SERVICE KIT NO. SK-113

Defroster Improvement

AA5-0002 thru AA5-0010

Figure 1.

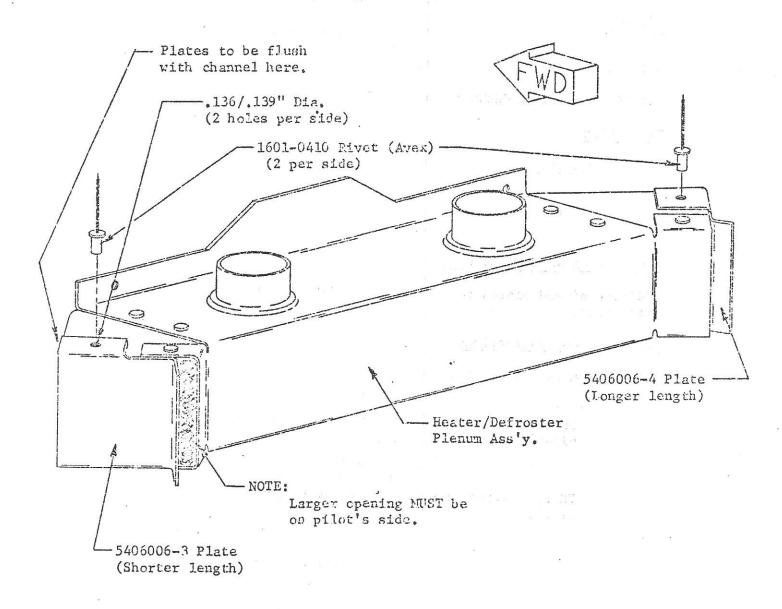
Addition of end plates to heater box to improve flow of air through defrosters.

Install end plates as shown in Figure 1.

Shorter plate (5406006-3) MUST be installed on the pilot's side of aircraft.

PK screws and Tinnerman nuts may be used in place of rivets.
